Amendment 4- IFB069SPRT21 (C) – Emile Griffith Ballpark Hurricane Repair Project on the island of St. Thomas

SUBJECT: Response to Bidders Questions, Emile Griffith

Response: see below. The copy is from Sheet S111.

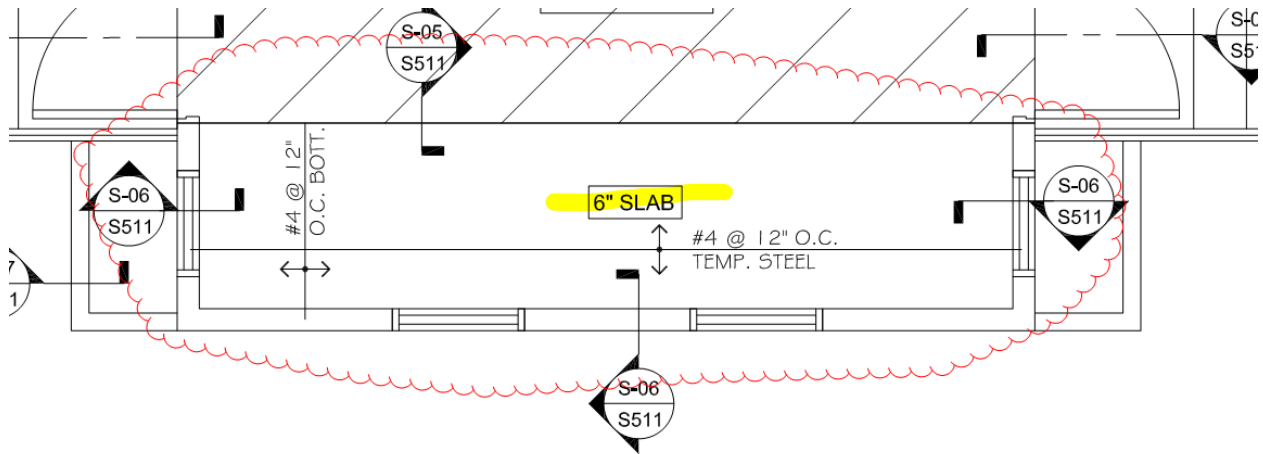
2. Are we to assume that item 15 - raised platform is the area in the pressbox.

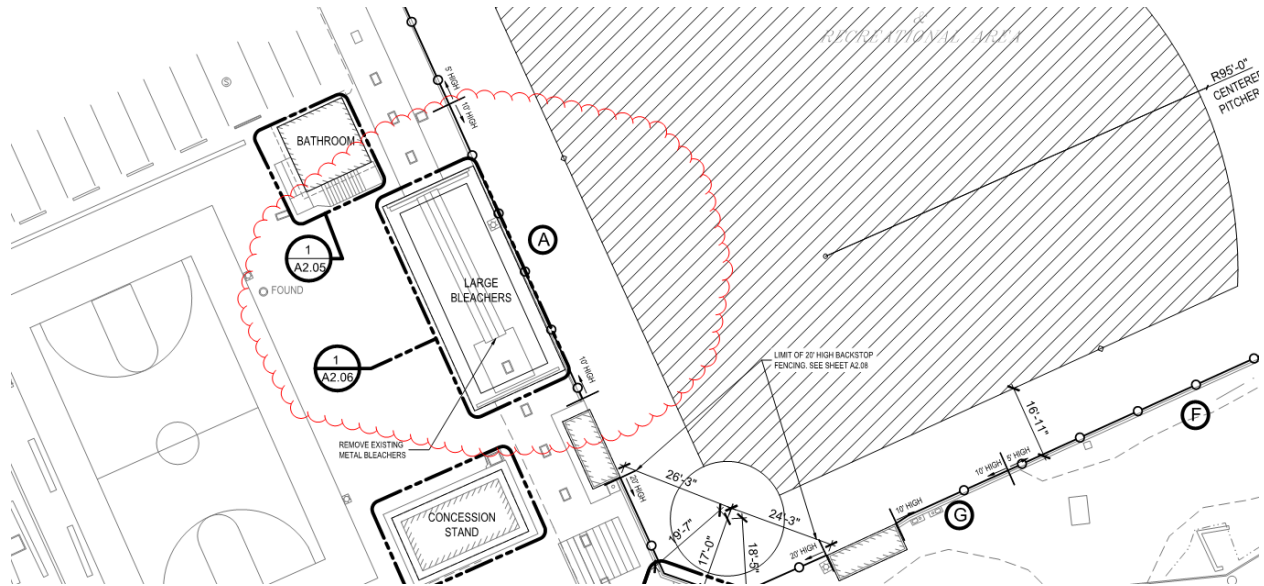
4. Item 29 refers to bleachers under Division 5 - Steel. Where are these specifically to be located?

Response: see site plan below. The structural design and Sheet A2.06 provides details on the construction.

Response: the copy below is taken from Sheet A2.06 which is part of the design for the bleachers that are to be constructed.

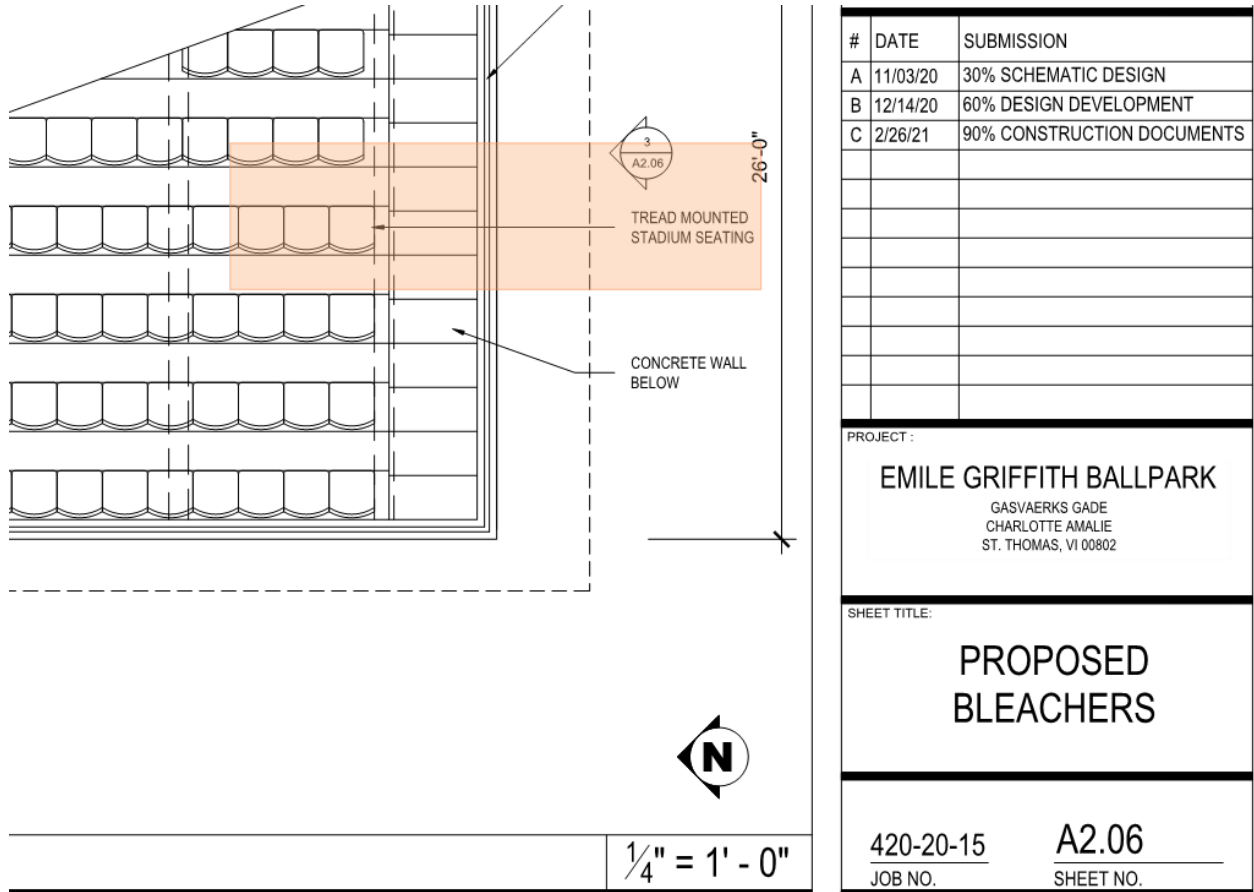
13. Which set of bleachers do the bleacher seats per line item 73 get installed

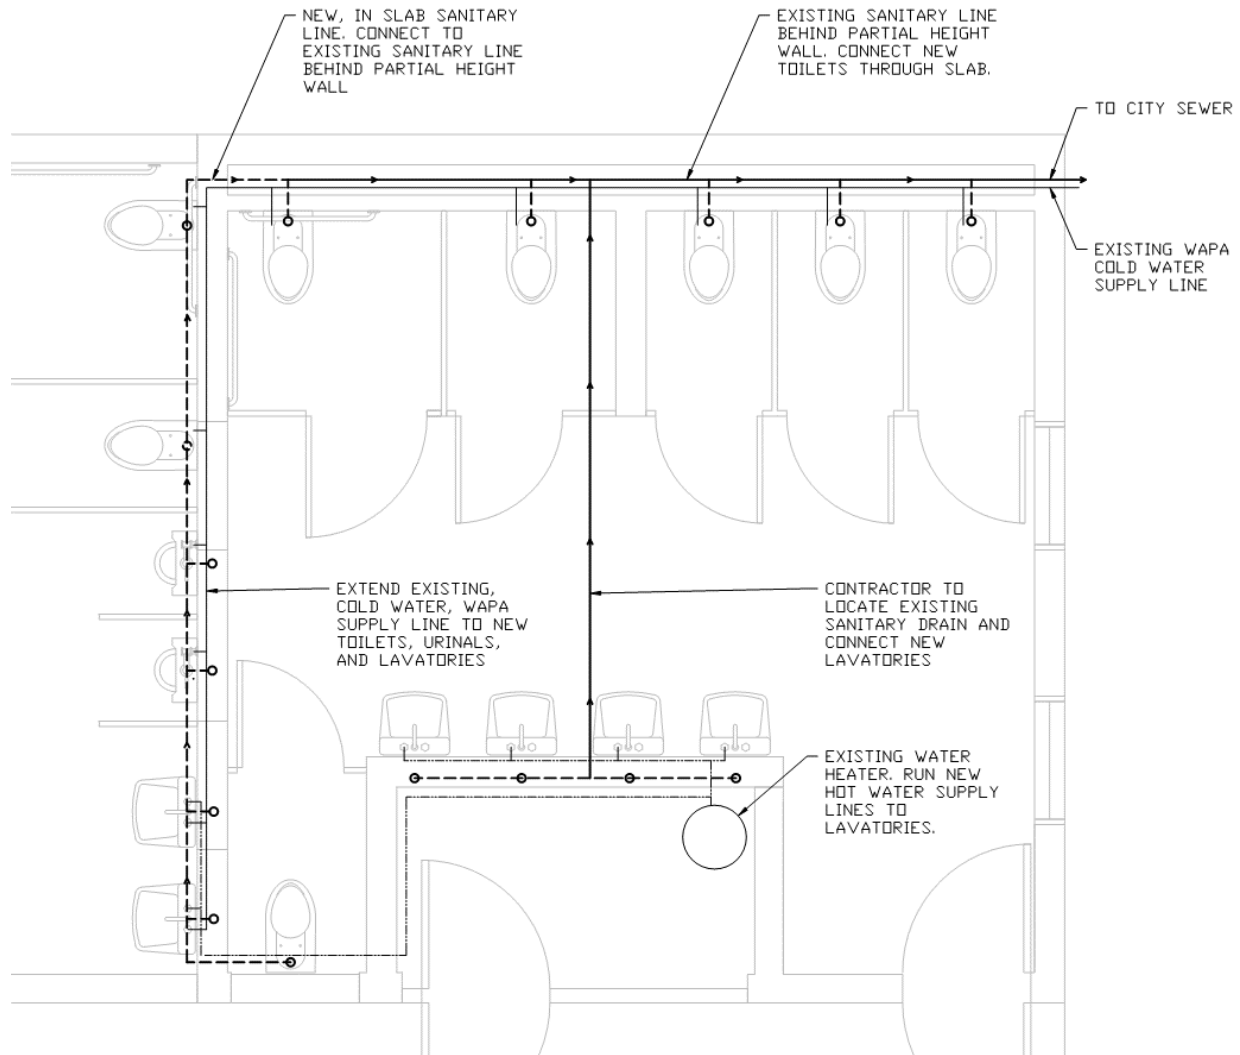
14. Please provide a schedule for the fixtures and equipment mentioned in line item 77.
Response: the floor plan below is taken from Sheet A5.02. The notes reference new fixtures.

Plumbing Fixtures Schedule	
Toilet	<u>Handicapped floor mounted flush tank water closet.</u> Shall be an American Standard Model 270AA, Cadet 3 Right Height Elongated 1.6 GPF toilet, vitreous china, cadet flushing system, tank type, floor mounted, floor outlet, with American Standard open front heavy duty commercial seat model 5901.100. Toilet lever handle shall be located on accessible side of toilet
Lavatory	<u>Handicapped wall hung lavatory. (cold water only)</u> Shall be an American Standard Missouri Lavatory Model 0436.004US, 4" center faucet holes, vitreous china, wall mount with concealed arms support. Faucet shall be a Monterey model 5502.145 with 4" centers and standard 4" lever handles and grid strainer drain.
Urinal and Flush Valve	<u>Handicapped Urinal and Flush Valve</u> Shall be an American Standard Washbrook Model 6501.511 3/4" top spud. 0.125 to 1.0 GPF. Urinal includes American Standard manual flush valve Model 6590.001 3/4" top spud.
